**BUCKSPORT INFRASTRUCTURE & PROPERTY COMMITTEE MEETING
5:30 P.M., THURSDAY, OCTOBER 11, 2018
BUCKSPORT TOWN OFFICE**

Re: Woodland Heights/Spruce Street
Drainage Review

RE: Central Street Parking Lot
Expansion Concept Plan

FIGURE 1

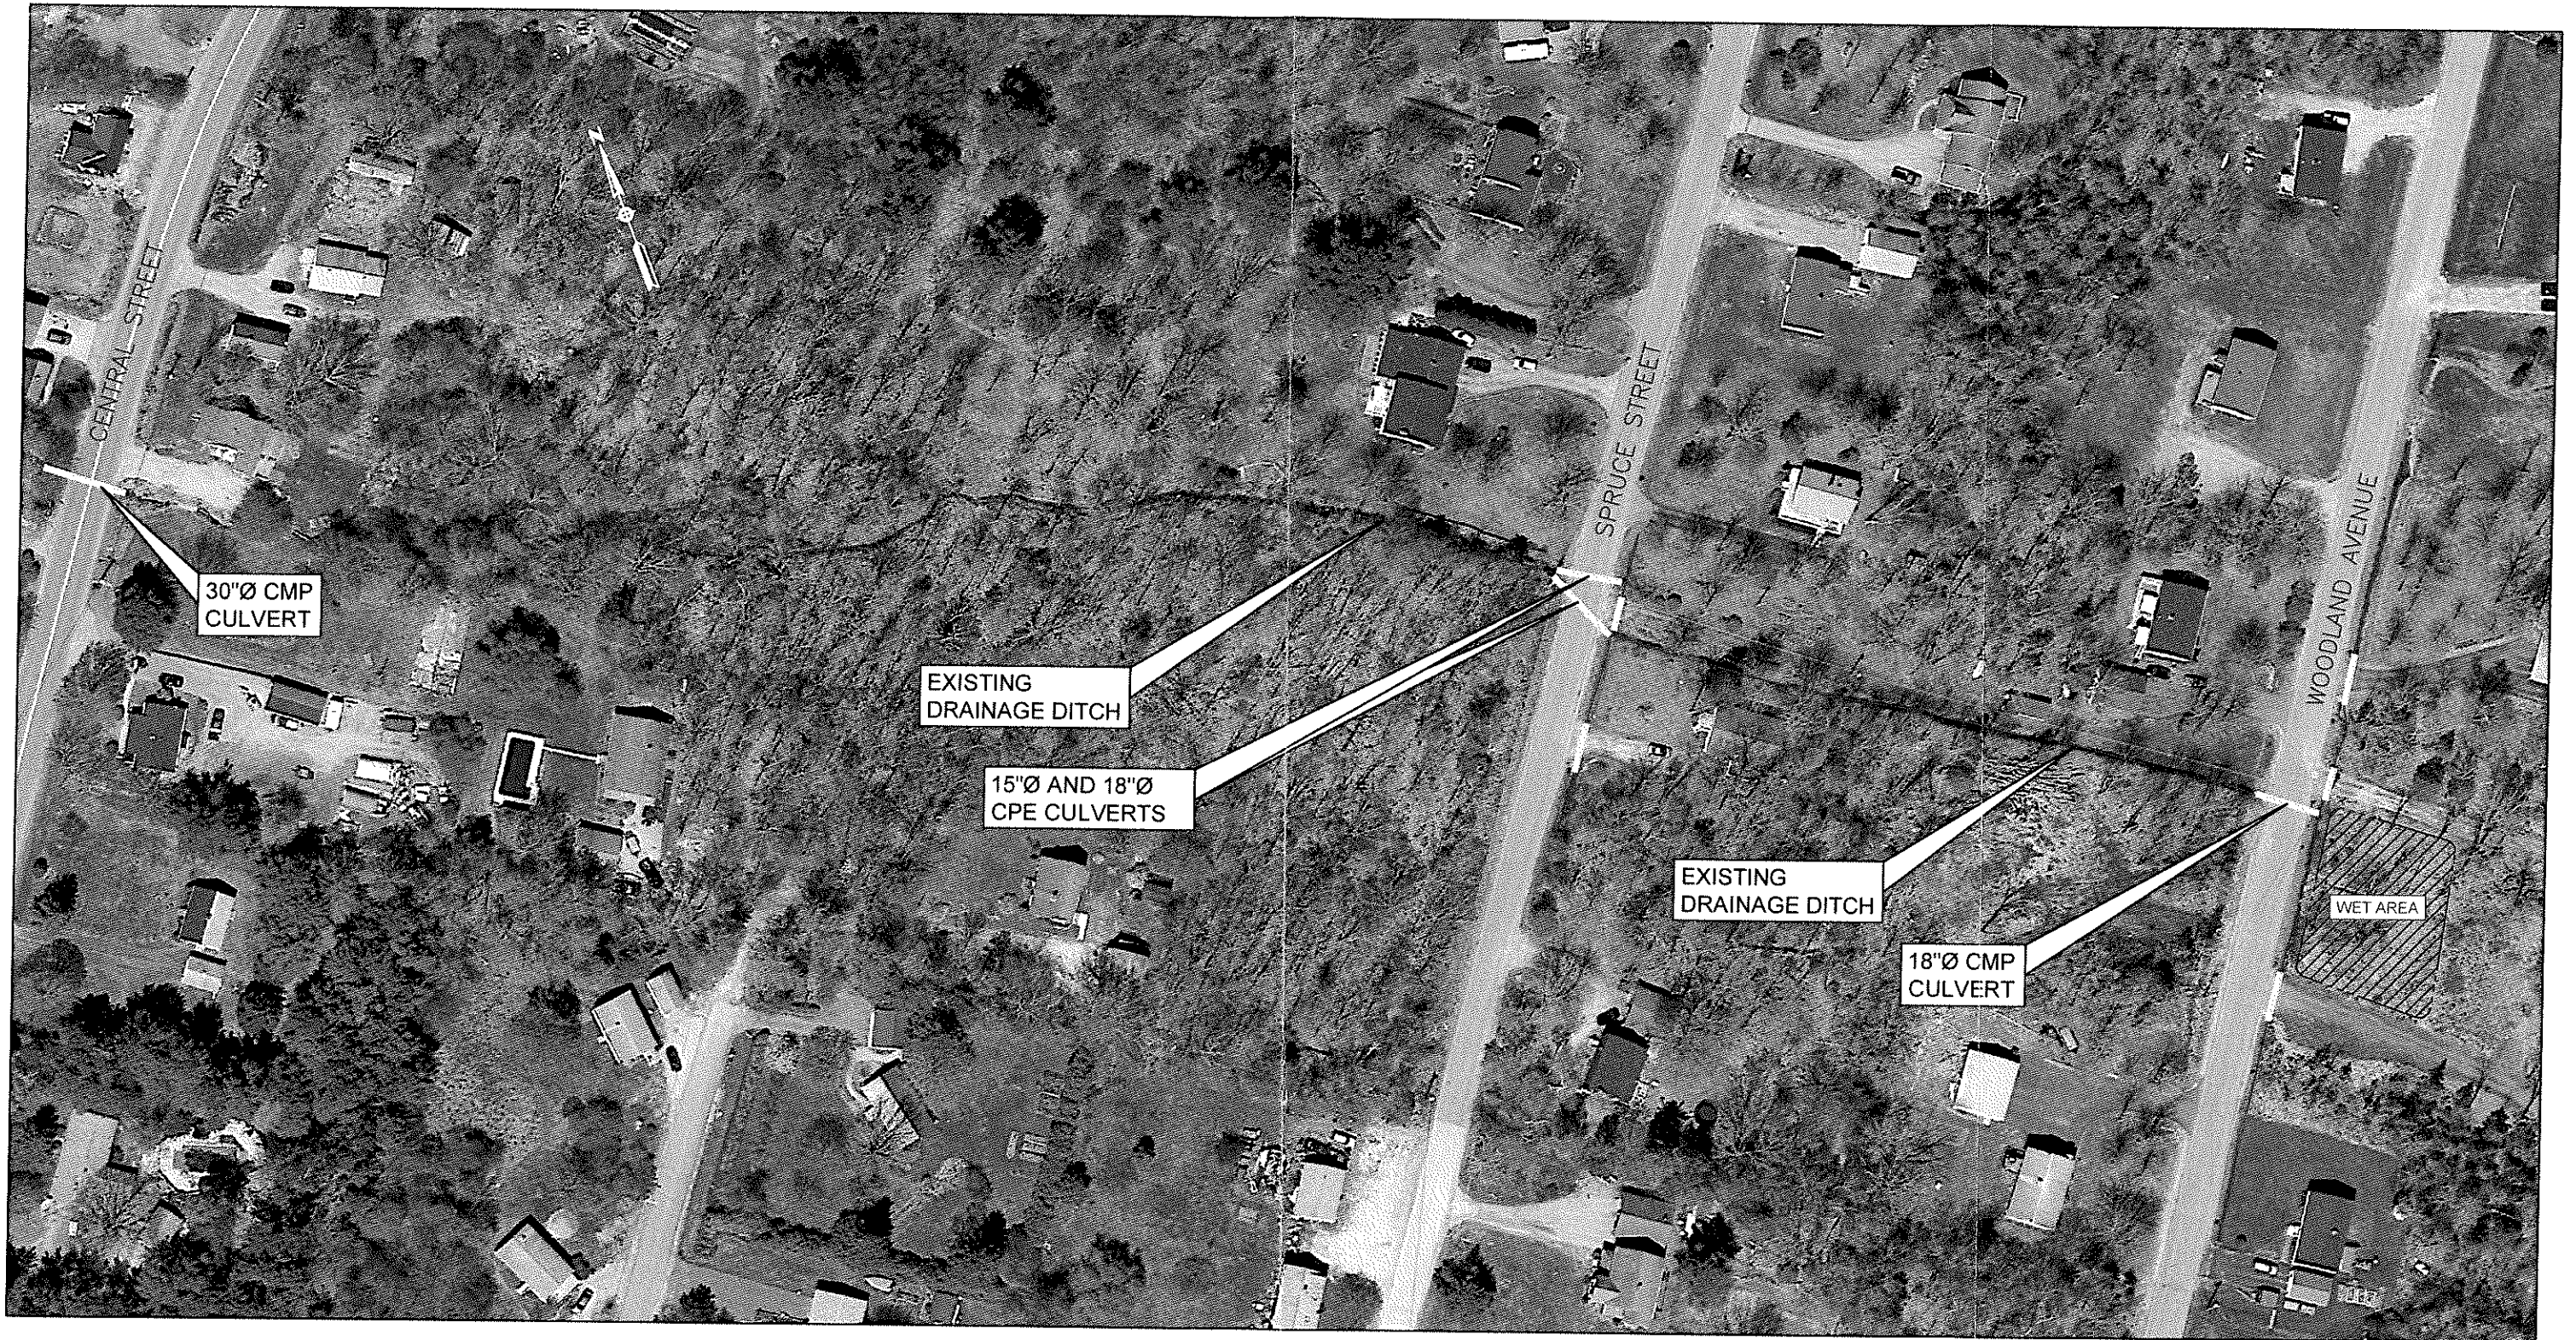
As requested, we have completed a review of the drainage system which exists between Woodland Heights and Spruce Street in the Buck subdivision, and outlets to Central Street. The existing system is shown on the attached Figure 1. Surface runoff from the top of the hill near Race Course Road runs cross country and accumulates in a wet area east of Woodland Heights. The water crosses under Woodland Heights in an 18-inch corrugated metal pipe. It then flows cross country through a ditch located between house number 38 Woodland and the lot where house construction is currently underway on Woodland toward Spruce Street. At Spruce Street, there are two culverts crossing the road conveying water west toward Central Street. One is 15-inch diameter and the other is 18-inch diameter corrugated plastic pipe. The water then continues cross country in a ditch, then ends up crossing under Central Street to a large wetland area through a 30-inch corrugated metal pipe with a large flow capacity.

It has been reported that standing water in the wet area upstream of Woodland Heights and in the ditch between Woodland and Spruce Street are causing nuisance conditions. In larger rain events, stormwater has been observed to pond, and reportedly run over the road when culvert capacity is exceeded. It should be noted that these events occurred when winter conditions were present, which may be a contributing factor to this issue.

- Lower the culvert crossing Woodland Heights to reduce the amount of standing water east of the road.
- Regrade the existing drainage ditch between Woodland Heights and Spruce Street to drain standing water. We would recommend use of stone check dams to slow velocity and it may be necessary to use rip rap around the inlet to the culverts under Spruce Street.
- Lower the 18-inch culvert under Spruce Street to the new ditch elevation. Replace the 15-inch with a second 18-inch pipe.
- Re-ditch outlet of the culverts and add rip rap to stabilize the area and slow velocity.

The ditch between Woodland and Spruce could be addressed to move water by changing the slope so water would not stand there. There appears to be a high area in the ditch near 38 Woodland that is holding water which could be drained by ditch improvements. Once this is done, the culverts under Spruce might still need to be reset to relieve the ditch, but not changed in size. This may still achieve the desired reduction of standing water in the ditch while reducing the risk of erosion to the downstream properties.

In summary, our recommendation would be to complete the ditch improvement at this time, and see if this improves the situation by removing standing water. The next incremental step would be to modify the storm drains crossing Spruce Street increase the flow capacity, however it might be necessary to secure easements to access the areas on either side of the road involved in the construction of the drainage. There may also be downstream impacts from this change.

We do not recommend changing the culvert crossing Woodland Heights at this time. Retention of the water in this area does not appear to be damaging property and serves an important function in dampening flow rate peaks and water quality as stormwater filters through the wooded area.
